June 24, 2022

From: Alameda County Wind Repowering Technical Advisory Committee

Re: Mulqueeney Ranch Micro-siting Recommendations (Supporting Documentation)

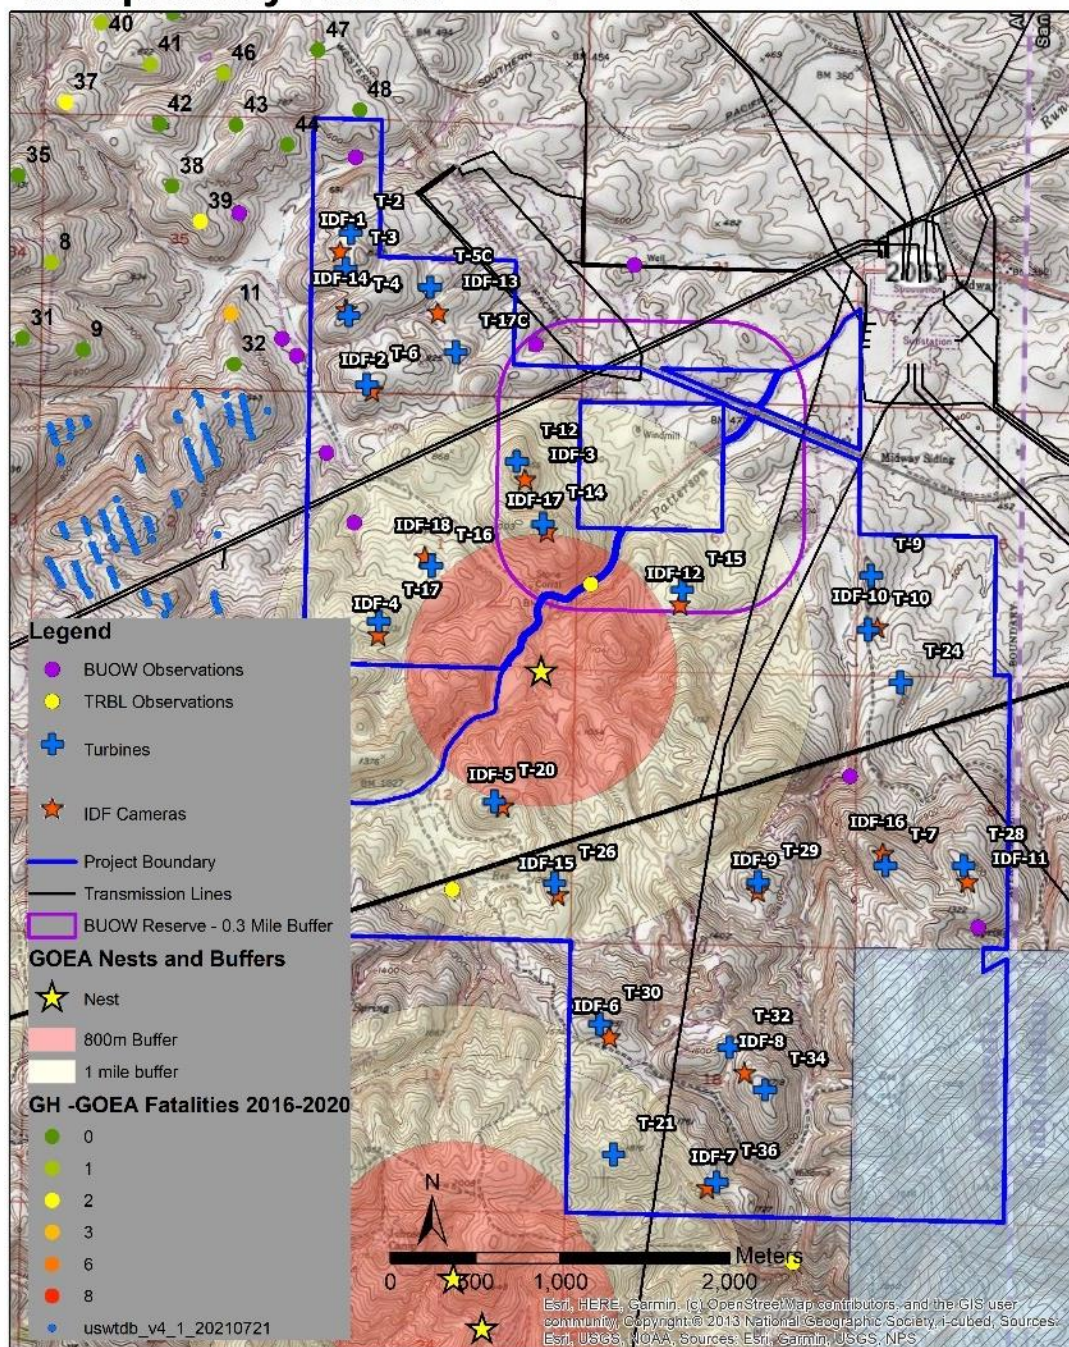
- *Reference data:* golden eagle nest locations and buffers (Fig. 1; data provided by Proponent, ICF 2020b, Estep 2020a, and Wiens and Kolar 2021).
- *TAC findings:* 8 turbines within 1 mile of golden eagle nests:

- Midway Rd. nest (along Patterson Pass Rd.): WTG-12, WTG-14, WTG-15, WTG-16, WTG-17, WTG-20, WTG-26; Tesla nest/activity center: WTG-21
- *Discussion:* The PEIR and SEIR direct the Proponent to coordinate with the USFWS regarding turbines proposed to be located within two miles of eagle nest sites. The USFWS acknowledges that the Proponent has applied for an eagle incidental take permit. As previously communicated in TAC meetings, it is the USFWS policy to recommend that no turbines be constructed within two miles of eagle nest sites based upon our analysis of breeding golden eagle telemetry data (USFWS 2020). Golden eagles spend 80% of their time within 1.6 miles of in-use nest sites, and over 90% of their time within two miles (USFWS 2020). Therefore, the USFWS considers turbines within 1-2 miles of golden eagle nest sites to be of high risk. To find a practicable compromise for wind energy operations in the Altamont, the USFWS recommends that turbines not be constructed within one mile of eagle nest sites, or that turbines located within one mile of nests be curtailed during daylight hours during the breeding season until it is verified that nests are not in use. The TAC acknowledges and appreciates the Project’s efforts to not site turbines within one-half (0.5) mile of known eagle nests. As summarized in Table 1, there are eight (8) turbine sites located within one (1) mile of golden eagle nest sites, a factor that the TAC considers to make them high-risk turbine sites. The TAC supports USFWS’s recommendation for

- *Related TAC Recommendation (GOEA Consideration 1): GOEA Curtailment.*

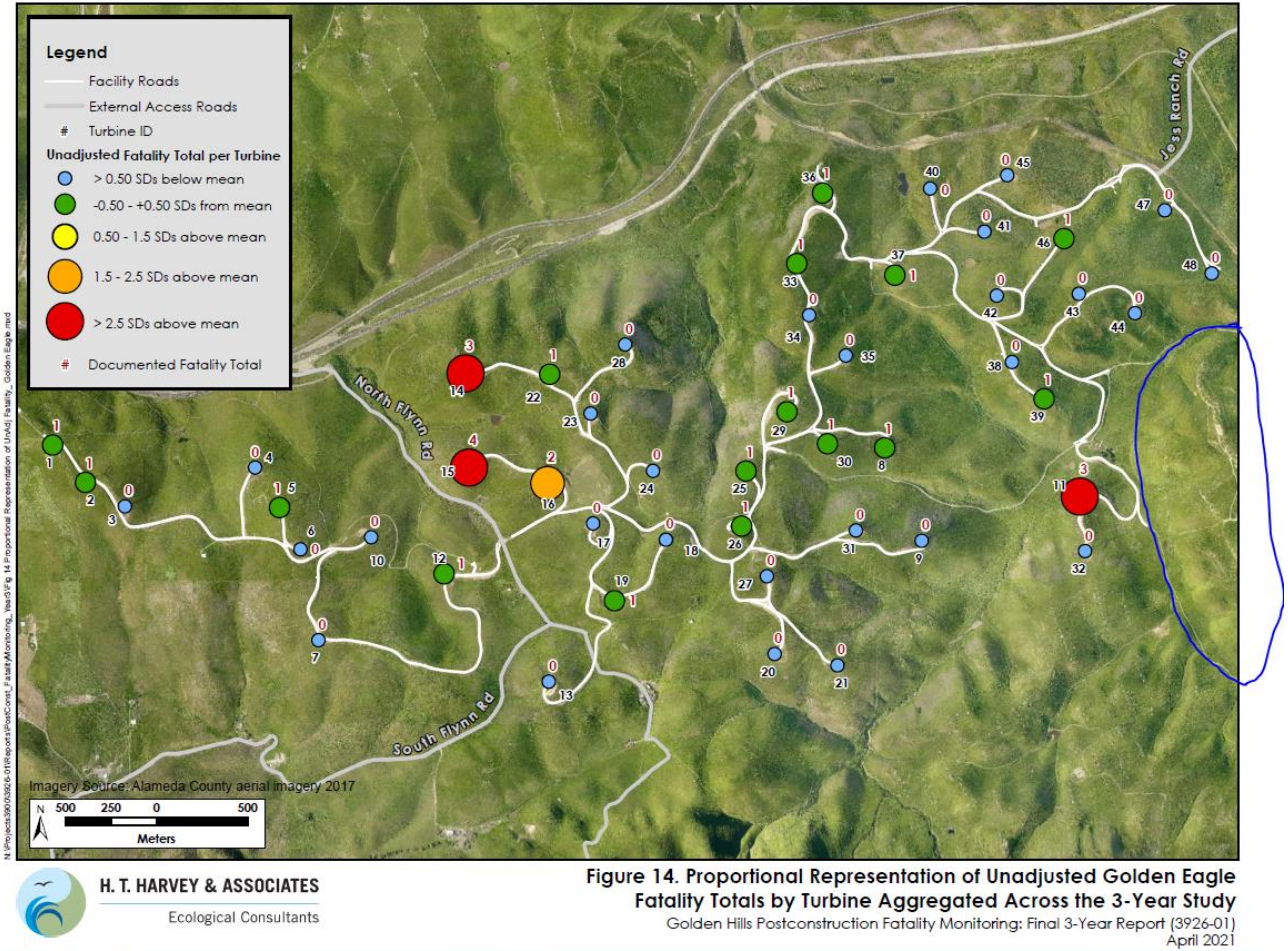
- *Reference data:* 2016-2019 and 2022 Golden Hills monitoring data (Fig. 2, H. T. Harvey & Associates, 2021; 2022 interim fatality reporting to CDFW and USFWS).
- *TAC findings:* 4 golden eagle fatalities in proximity to Project footprint (in proximity to ridgeline of Project turbines WTG-2, WTG-3, WTG-4, and WTG-6):
 - 2016-2019 Golden Hills WTG-11 (3 golden eagle)
 - 2022 Golden Hills WTG-32 with IdentiFlight tower (1 golden eagle). Note the TAC discussion of IdentiFlight provided in Appendix B.
- *Related TAC Recommendations (GOEA Consideration 2): Turbine Removal and/or Phased Approach for Turbine Approvals.*

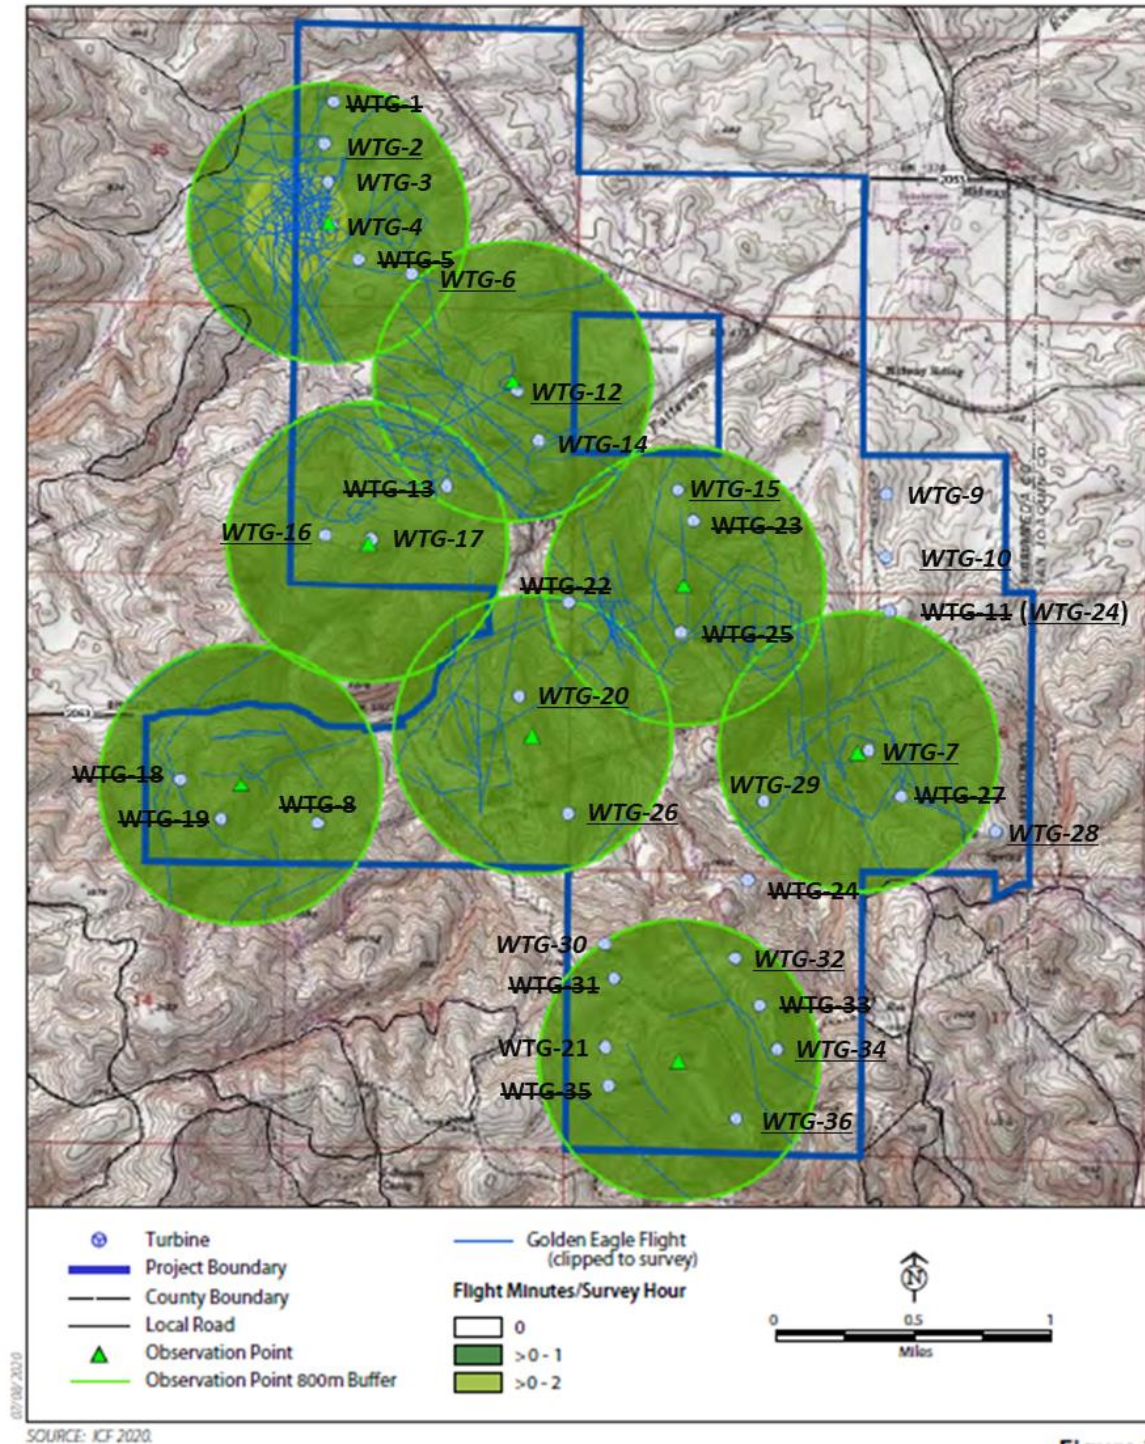
- *Reference dataset (a):* golden eagle use surveys (Fig. 3; ICF 2020b)
Survey description from Estep (2020a): "... [D]ata on bird abundance and distribution are important factors in assessing risk. For purposes of this assessment, ICF conducted point count raptor surveys at eight observation points spaced throughout the project area. Data were collected over a one-year period and summarized as flight minutes per survey hour. Use areas were then characterized within the project area using a kernel density approach to identify use and concentration areas into three zones. For purposes of this assessment, data for golden eagle occurrence was used as a risk factor. Higher risk was associated with higher eagle concentration."

- *TAC findings re: dataset (a)* (via Estep 2020a and ICF 2020b) dataset (a): Documented golden eagle use, particularly with heavy use in close proximity to proposed turbines in northwest corner of Project footprint (WTG-2, WTG-3, WTG-4, and WTG-6).

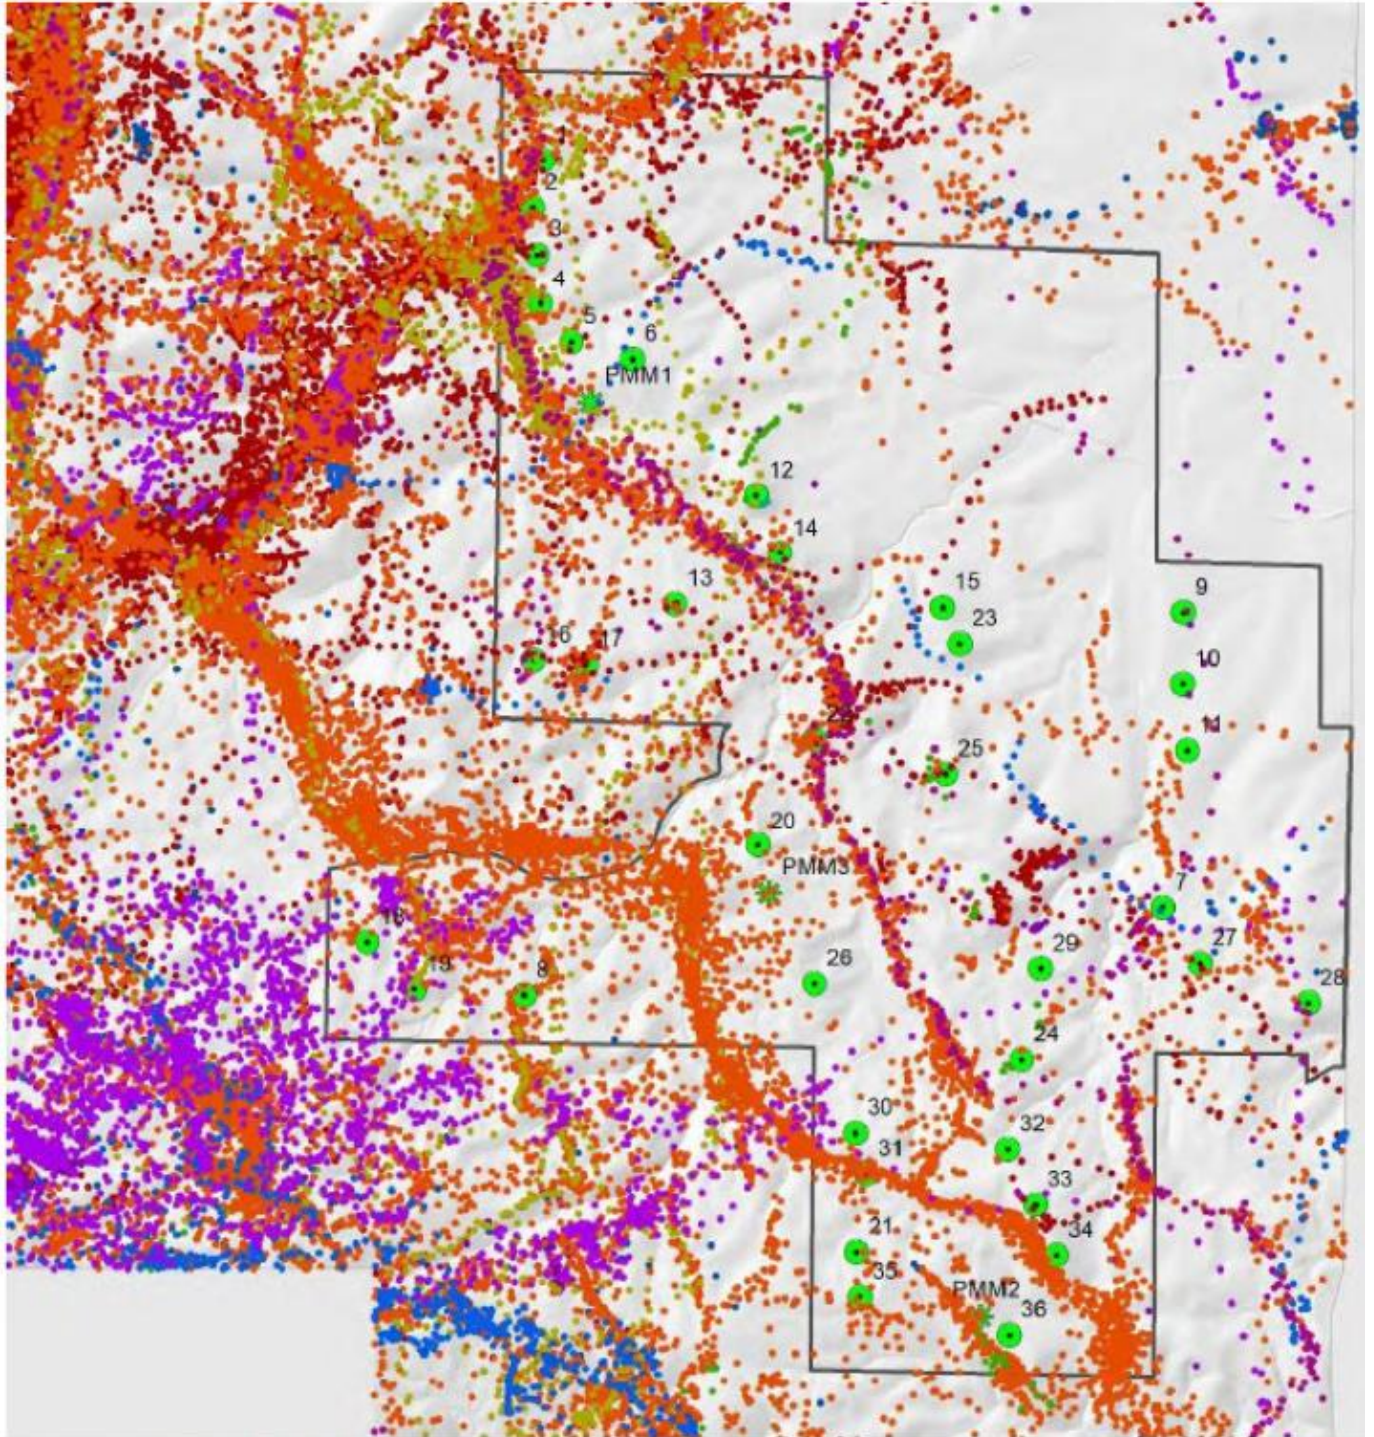
- *Reference datasets (b, c, and d):* golden eagle GPS telemetry data (Figs. 4, 5, and 6) and NREL predictive flight model (Fig. 7), i.e.:
 - golden eagle-telemetry points of 11 birds <200 m above-ground level between 2013 and 2019, as supplied in letter submitted by Doug Bell to County and TAC (Fig. 4; Bell 2022b per Smallwood 2021);

- *TAC findings:* The telemetry observations (Figs. 4-6) and modeled data (Fig. 7) correspond with golden eagle high-use areas as identified in Eagle Use Surveys conducted by ICF (2020b; Fig. 3), especially in the vicinity of proposed turbines WTG-2, WTG-3, WTG-4, and WTG-6 in the northwest of the Project footprint. Golden eagle use is also heavy at another turbine location (WTG-14).
- *Related TAC Recommendations (GOEA Consideration 3): Turbine Removal and/or Phased Approach to Turbine Approvals.*

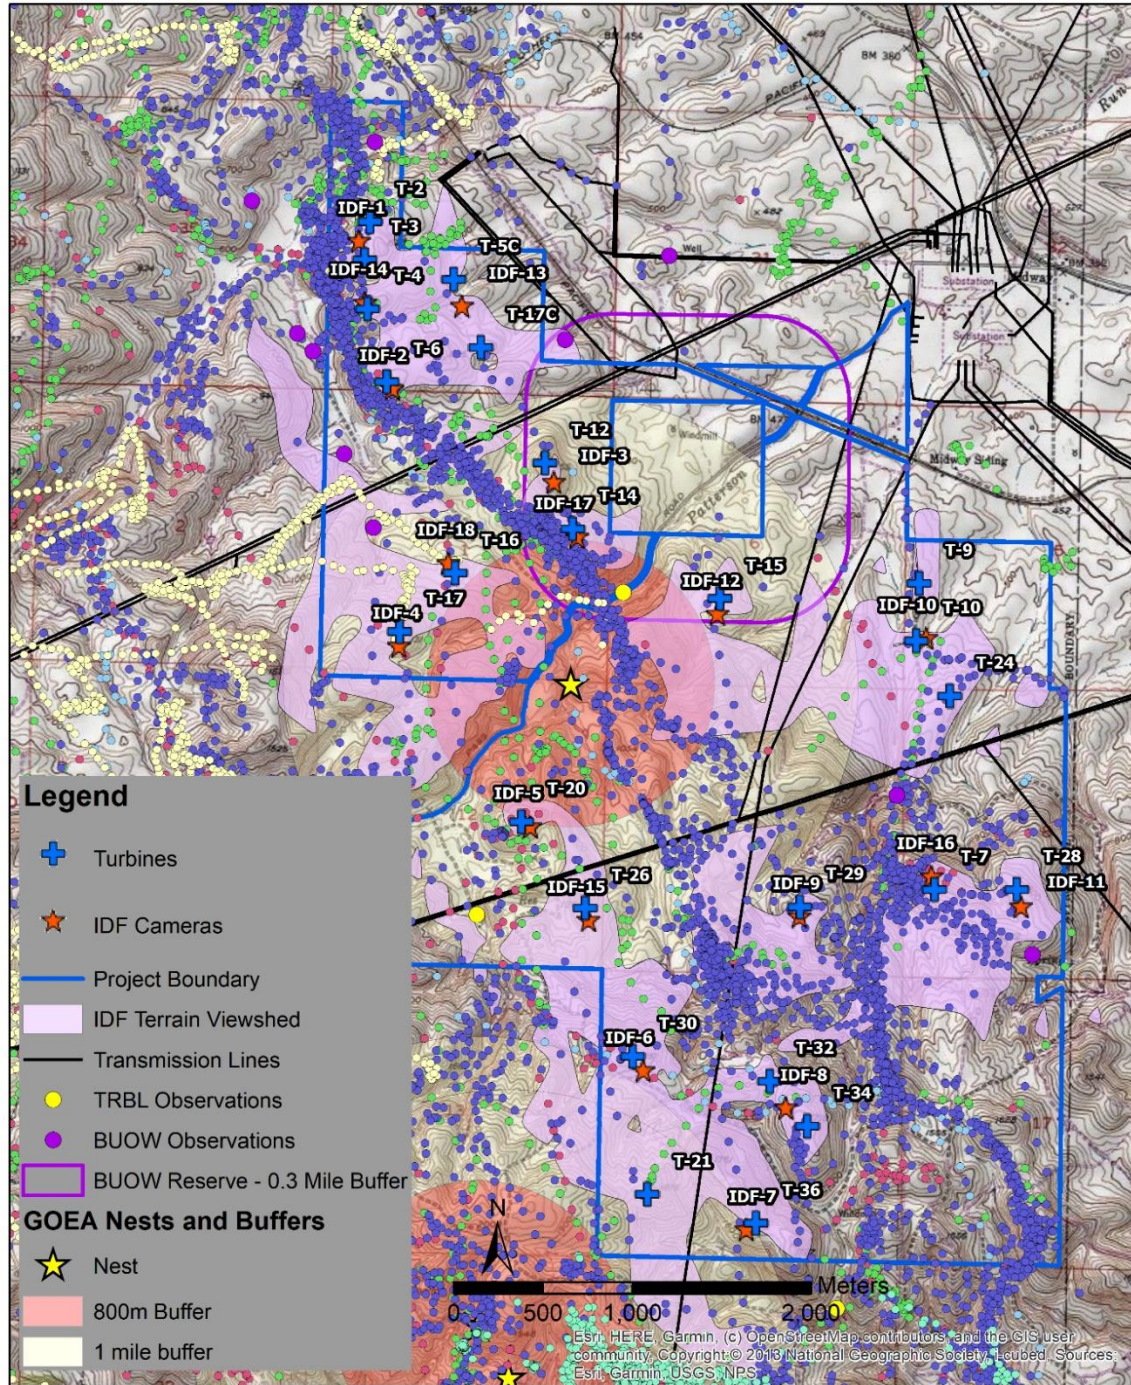
- golden eagle telemetry points of 6 birds <200 m above-ground level between June 30, 2019 and December 31, 2020 (Fig. 5; D. Bell, unpublished data);

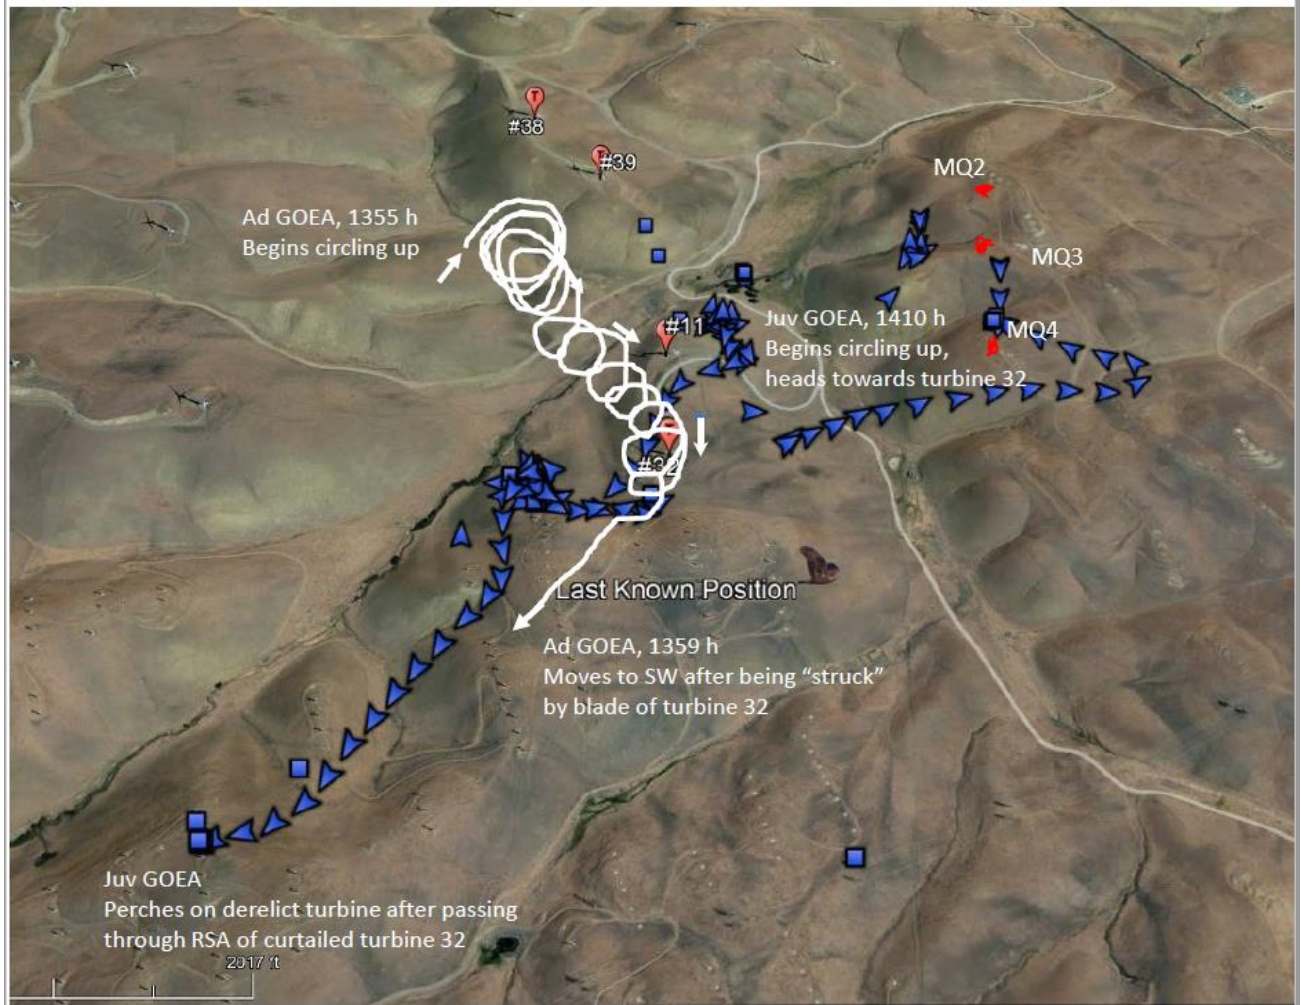
- golden eagle observed flight behavior and telemetry points of adult and juvenile golden eagles interacting with Rotor-Swept Area of Golden Hills WTG-32 and the airspace of the proposed turbine locations near proposed Project turbines WTG-2, WTG-3, and WTG-4 on December 10, 2021 (Fig. 6; Bell 2022a);
- NREL modeling of predicted GOEA flight patterns (Fig. 7; Sandhu 2022 [Appendix C]);
